SUBMITTAL IDENTIFICATION SHEET

WEBSTER UNIVERSITY ISB	
PROJECT NAME	
8274 BIG BEND BLVD	
ADDRESS	
NUMBER	
WEBSTER UNIVERSITY	
OWNER	
CANNON DESIGN	
ARCHITECT / ENGINEER	
Joe Voypick	
SUBMITTED BY	
077100-012	
CONTRACTOR / CM SUBMITTAL NO.	CANNON DESIGN SUBMITTAL NO.
	077100
DRAWING / DETAIL REFERENCE	SPECIFICATION SECTION / PARAGRAPH
MANUFACTURER / SUPPLIER	ITEM / PRODUCT ID
REQUIRED DATE	PRIORITY
	CRITICAL

PROJECT: 15051-Webster University Interdisciplinary Science Building

RE: Additional Coping Product Data for 8.A452

Custom Coping Detail

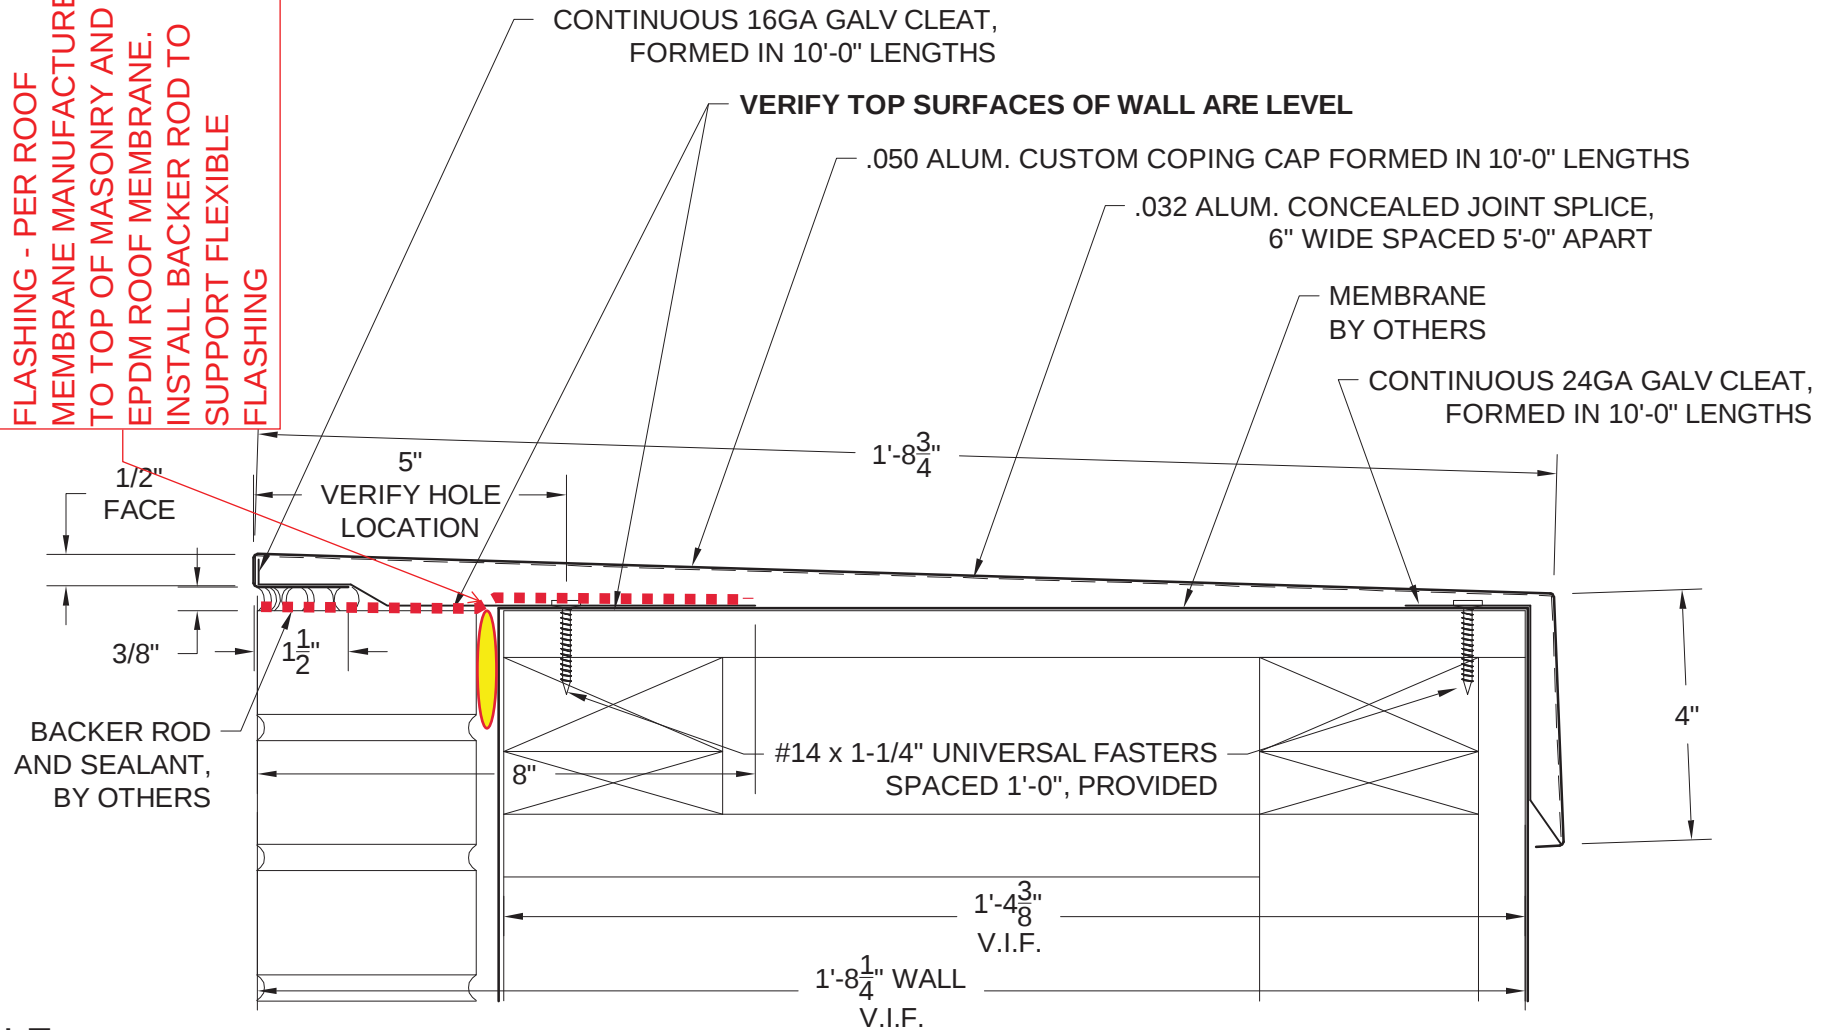
INSTALL 072726 - SELF-ADHERED FLEXIBLE FLASHING - PER ROOF MEMBRANE MANUFACTURER TO TOP OF MASONRY AND EPDM ROOF MEMBRANE. INSTALL BACKER ROD TO SUPPORT FLEXIBLE FLASHING
